PLANNING COMMISSION
Meeting Agenda (Revised)
Monday – May 12, 2014
7:00 PM
City Council Chambers – 155 NW 2nd Avenue

City of Canby

Site and Design Review Staff Report

File #: DR 14-03/LLA 14-02

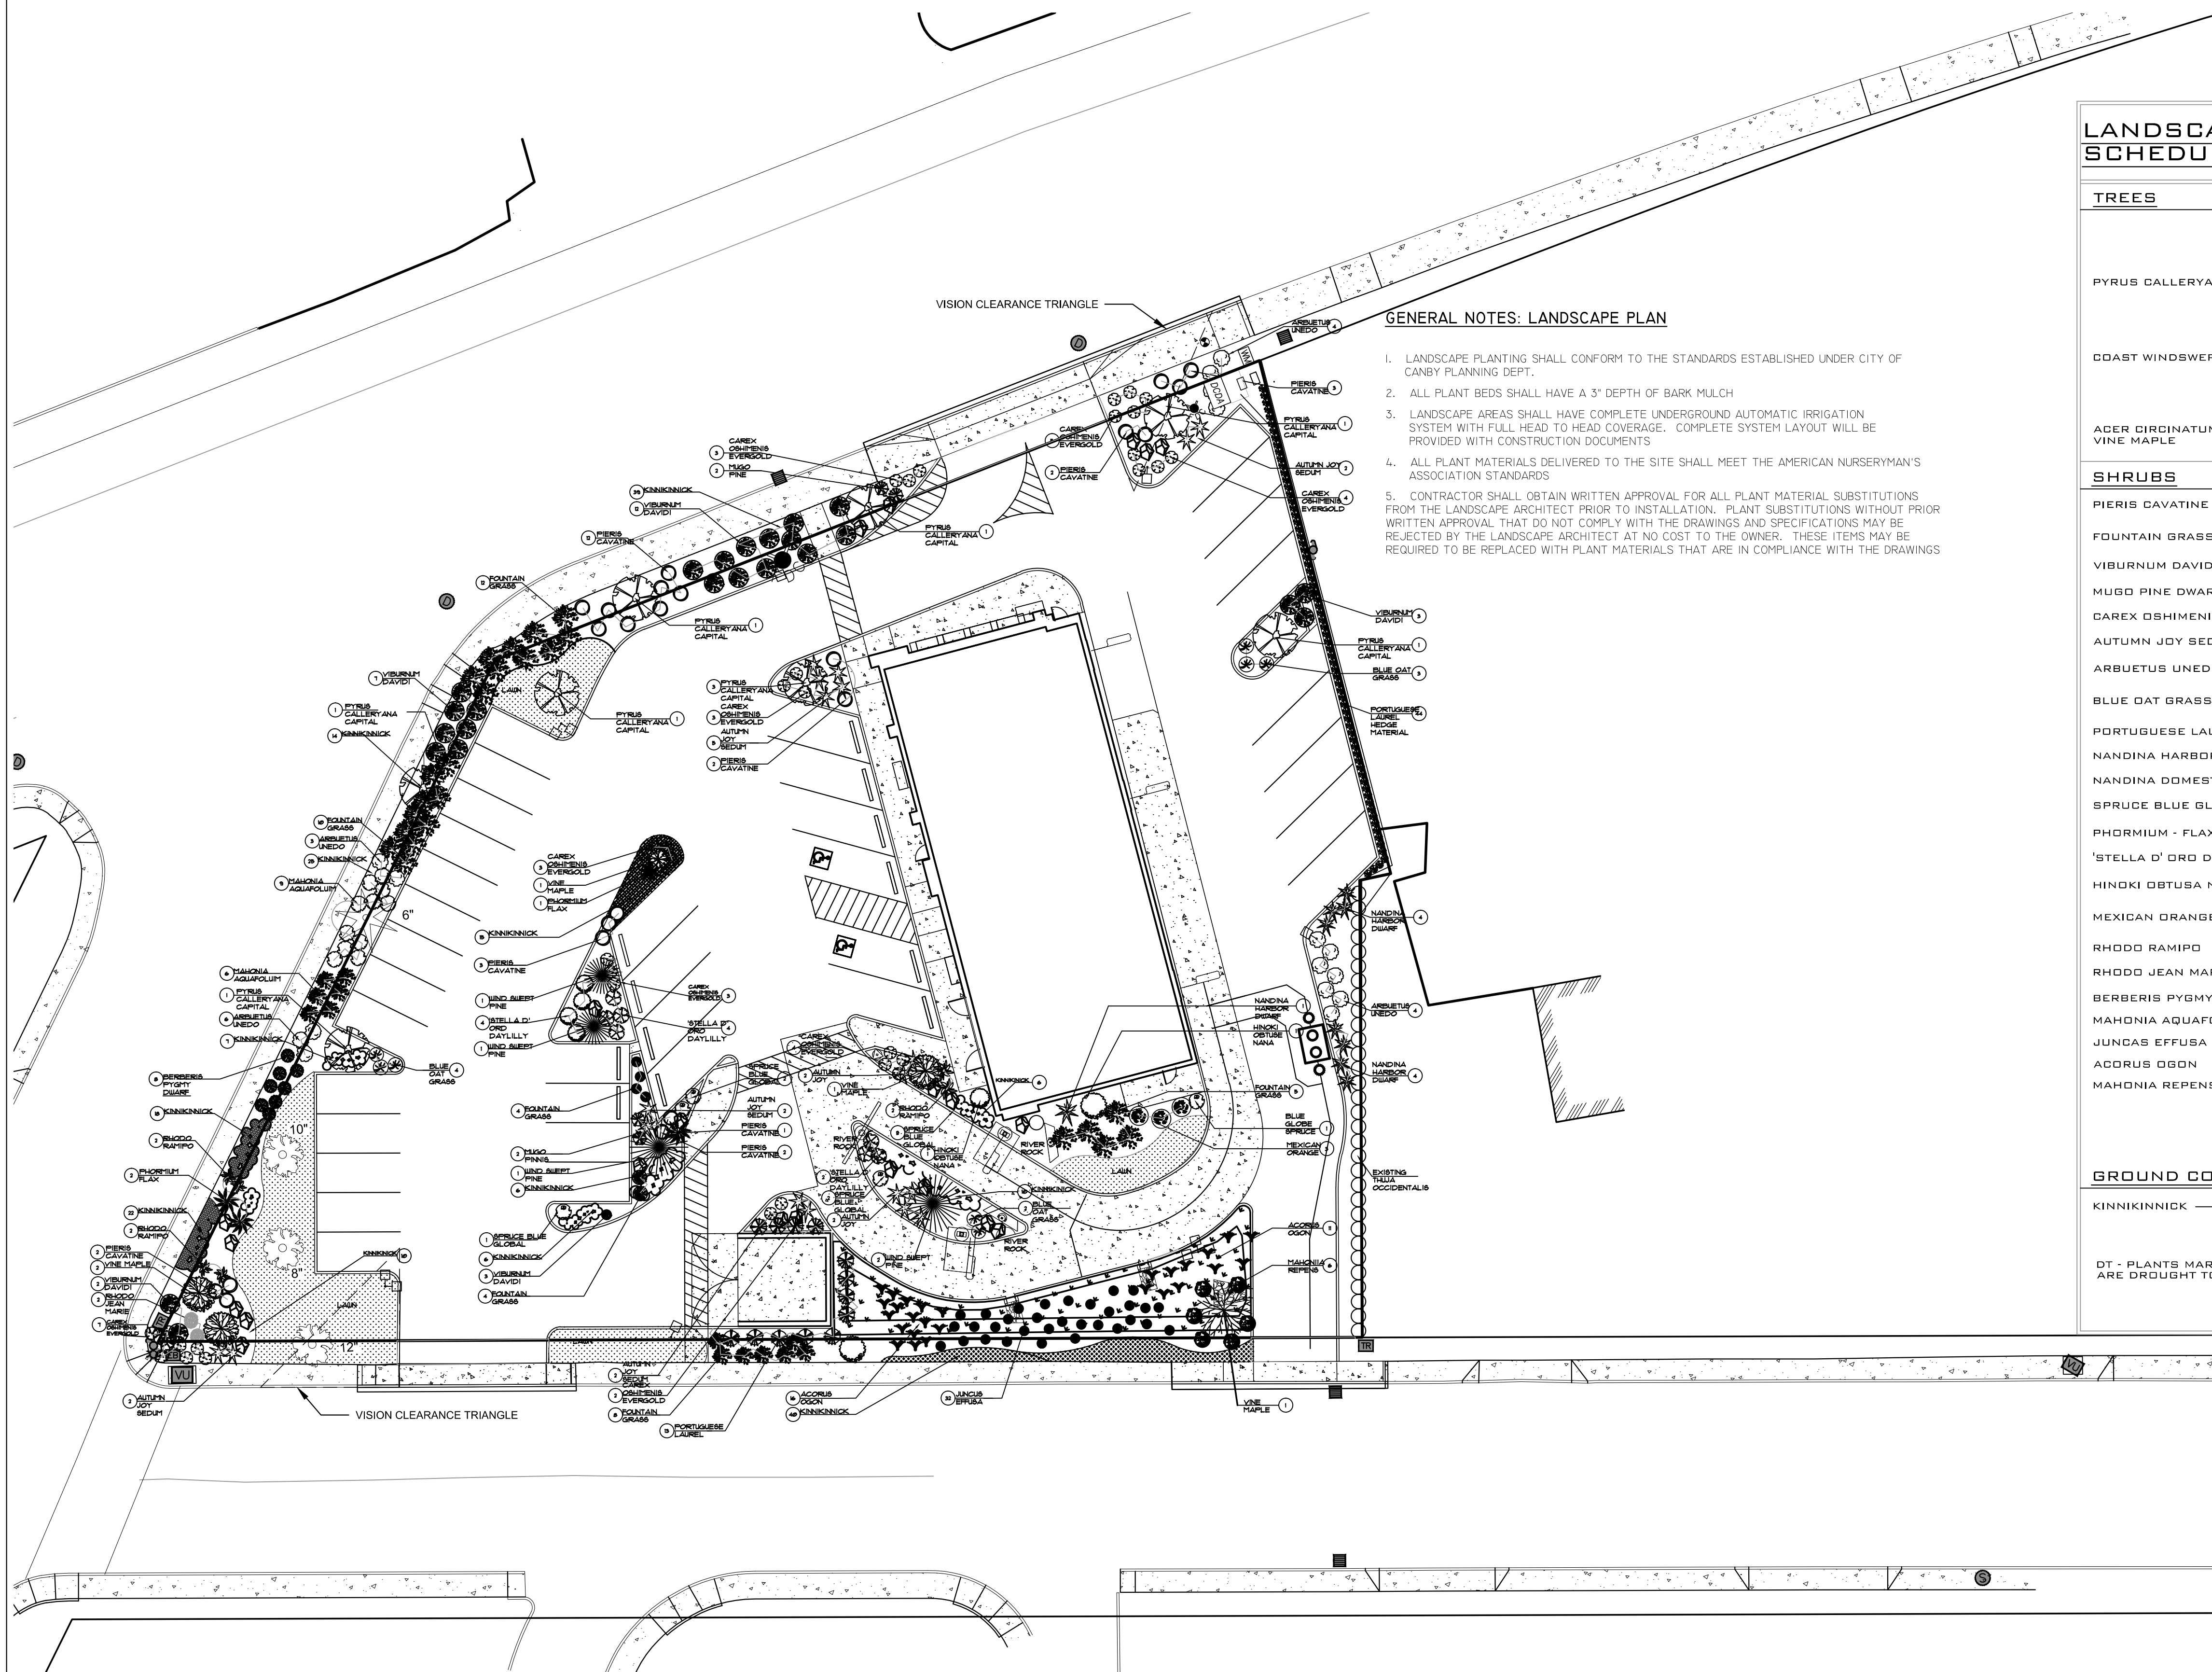
Finding: Trees and other plant materials to be retained are illustrated on the Landscape Plan (Sheet L1.0) under Exhibit B. Several healthy trees and frontage landscaping are proposed to be retained along the corner of SW 2nd Avenue and Birch Street, as well as a tree located along SW 1st Avenue (Hwy99E).

Finding: As noted on the Landscape Plan notes Sheet L1.0 of the plan set identified as Exhibit B), the landscape plantings will conform to the standards established under by the City of Canby. The plant beds will have a 3-inch depth of bark mulch, as well as an underground automatic irrigation system. These elements will work to insure the longevity and continued vigor of all plant materials on-site. By this commitment, the applicant will satisfy this standard.

Finding: As illustrated on the Landscape Plan (Sheet L1.0 of the plan set), the proposed Capital Flowering Pear and Vine Maple (deciduous tree) will be a minimum of 2-inch caliper, which will satisfy this standard. The proposed Coast Windswept Pines coniferous tree) are proposed to be five to six-

Finding: Perimeter landscaping is illustrated on the Landscape Plan (Sheet L1.0 of the plan set identified as Exhibit B) along all property lines that do not have pedestrian or vehicle accessways. All proposed trees are planted every 40-feet along the required setback of the vehicular use area. However, the applicant has not stated that item 1. above can be met within three (3) years, given the type of trees proposed. Review of the Landscape Plan indicates that the screening and buffering proposed for the site does a good job of satisfying item 1. above.

Finding: As noted on the Landscape Plan (Sheet L1.0) under note #3, landscape areas shall have complete underground automatic irrigation systems with full head-to-head coverage. This serves to meet this standard.
